Olympus Reference: FY25-089-F-1 Removal of SOLTIVE™ Fiber Products

URGENT FIELD SAFETY NOTICE

RE: SOLTIVE™ Laser Fiber Products (See Appendix 1 – Affected Products List)

Figure 1. Image showing the components of a SOLTIVE laser fiber device.

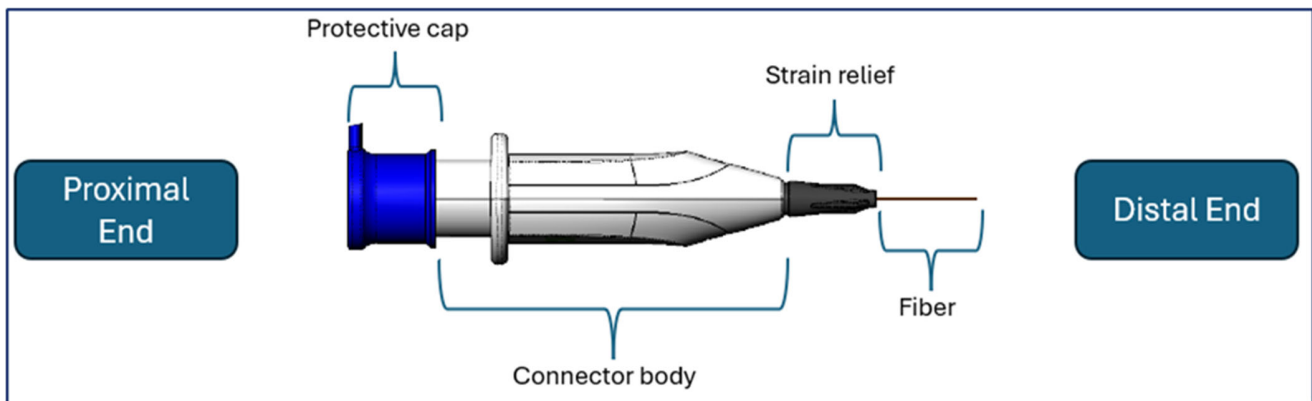
Olympus is initiating a Medical Device Recall / Product Removal for the SOLTIVE SuperPulsed laser fiber products listed in the Appendix 1 of this letter. New versions of these devices are being introduced that use a new material for the strain relief component (see Figure 1). These products along with either the SOLTIVE Pro or SOLTIVE Premium laser generator consoles and their accessories (footswitch, interlock connector, etc.) make up the SOLTIVE laser system, which is intended for use in incision, excision, resection, ablation, coagulation, hemostasis, and vaporization of soft tissue, with or without an endoscope, in the following indications: urology, lithotripsy, gastroenterological surgery and gynecological surgery.

Olympus identified and is implementing an alternate material for the strain relief component that will more immediately self-extinguish if it were to ignite. Olympus is requesting users transition to products incorporating the new strain relief material and return all existing unopened and unexpired SOLTIVE laser fiber products.
